SEAL FOR REVIEW ONLY  
ISSUED: 1/14/03  
THIS DOCUMENT IS FOR REVIEW ONLY AND NOT INTENDED FOR BIDDING, CONSTRUCTION, OR PERMIT PURPOSES. IT WAS PREPARED BY, OR UNDER THE DIRECT SUPERVISION OF:  
JIM O'BRIEN, P.E. #55861  
O'BRIEN ENGINEERING, INC.

T.F. STONE COMPANIES INC.  
T.F. STONE BUILDING  
LOT 1, BLOCK A, ADDISON STORAGE ADDITION  
**INITIAL EROSION CONTROL PLAN**  
ADDISON, DALLAS COUNTY, TEXAS

DATE: 1/14/03  
O.E. JOB NO. 138-02  
SHEET NO. 9  
OF 9 SHEETS

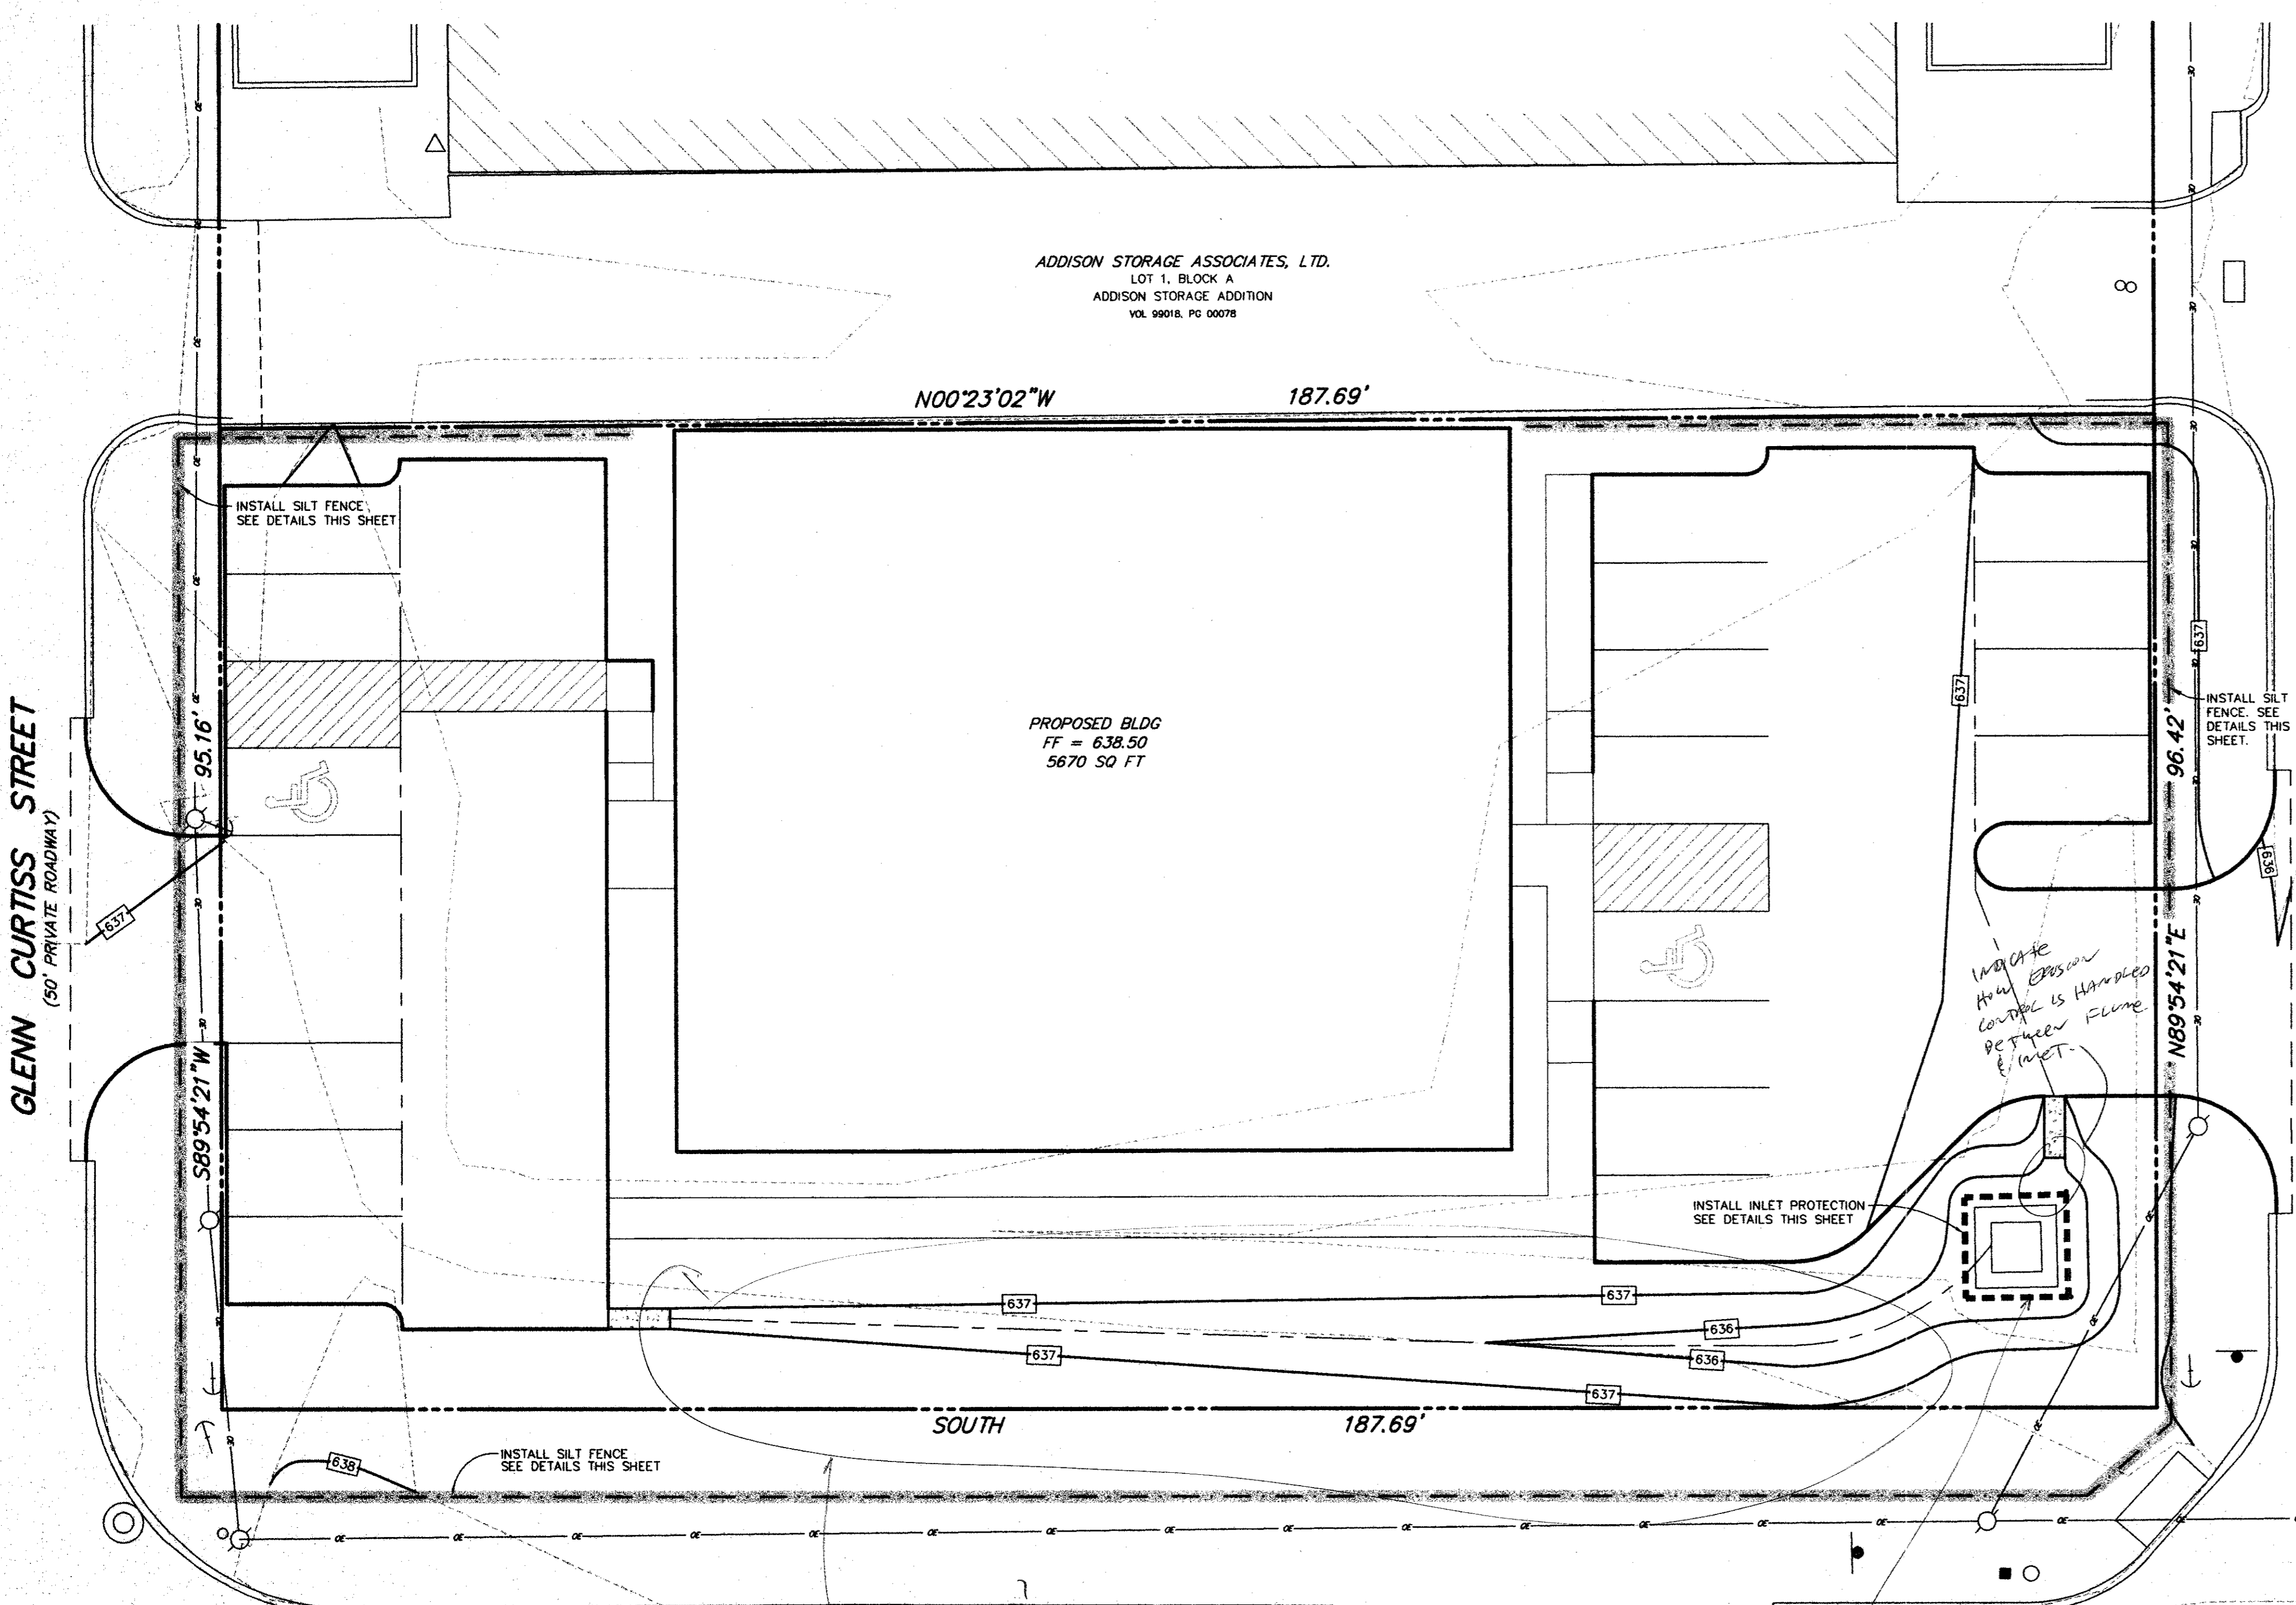
*erosion mat? Geo textile? Rock rip-rap? Hydraulically? ADDISON ROAD (72' RIGHT-OF-WAY) erosion control is not specifically stated on general notes!*

*INSTALL concrete apron around exist. drop inlet*
